<b>Location:</b>	<b>415 20<sup>th</sup> St</b>
<b>Assessor's Parcel Number(s):</b>	<b>PLN008063800711</b>
<b>Proposal:</b>	New construction of an office tower with 862,048 gross square feet of office floor area with a maximum height of 623 feet. The tower would include 38 floors consisting of primarily office use, in addition to a ground-level lobby with indoor and outdoor space alongside retail. The project would accommodate 262 automobile parking stalls in four levels of above-ground, podium-style parking garage, and an approximately 1/2-acre open landscaped amenity space atop the vehicular parking podium and a landscaped observation deck on the topmost floor.
<b>Applicant:</b>	415 20 <sup>th</sup> Street, LLC 1970 Broadway, Suite 400 Oakland, CA 94612
<b>Contact Person/ Phone Number:</b>	Kevin Chow, 415-399-6221
<b>Owner:</b>	415 20 <sup>th</sup> St LLC
<b>Case File Number:</b>	PLN20092
<b>Planning Permits Required:</b>	Regular Design, Conditional Use Permit for a large project, Variance for maximum setback

**SUMMARY**

PLN20092  
415 20th St  
008063800711

Date: 1/7/2021

# PODIUM PLAN

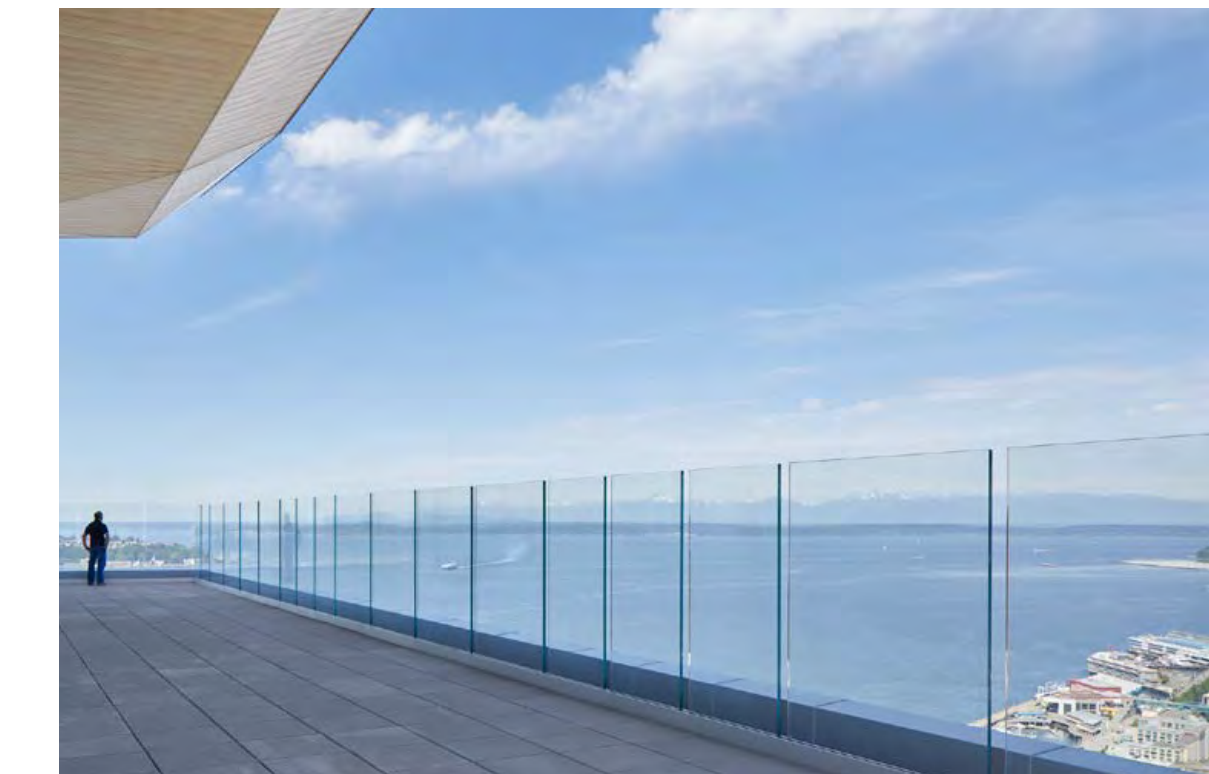
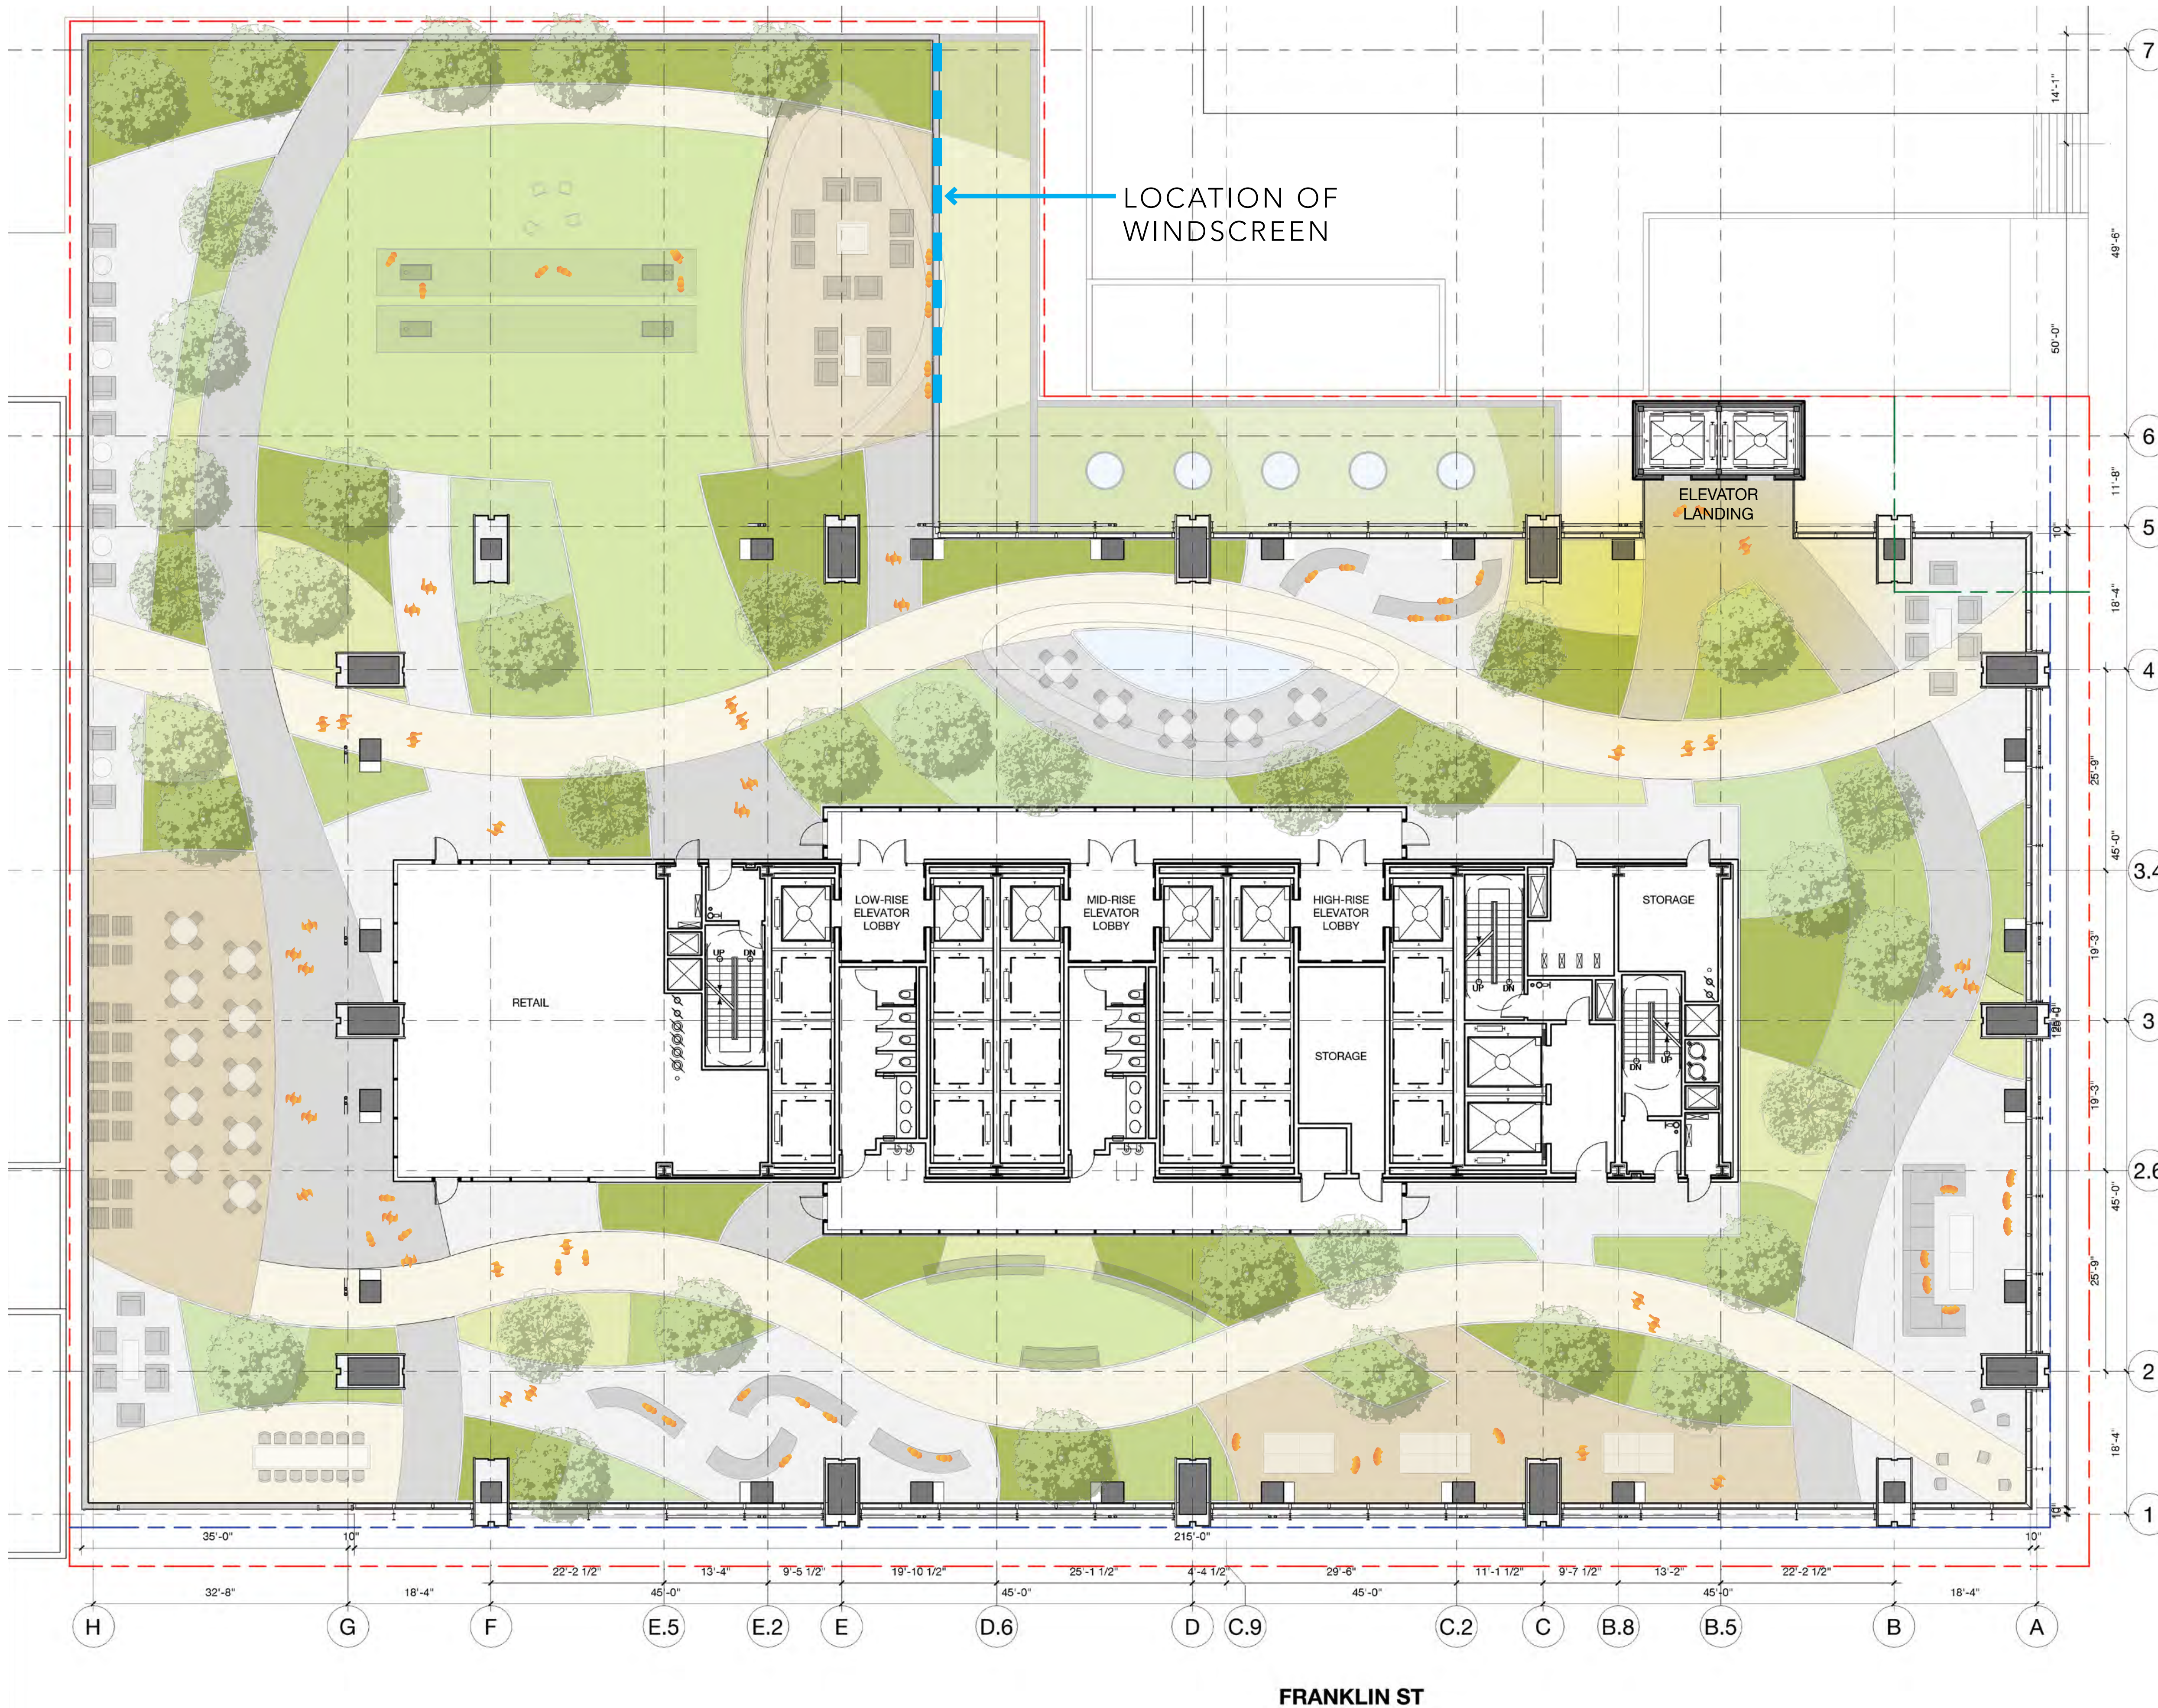
- The plan set includes a 10' high glass windscreen on the podium deck to reduce wind effects to the surrounding area. The screen would be installed in the interior of the project on the podium deck, but would be visible from 20<sup>th</sup> St. An elevation of the wind screen is shown on the Podium plan drawing and a plan view is shown on the Grading Elevation, P. 27. Does the DRC find the windscreen design to be consistent with the overall building design?
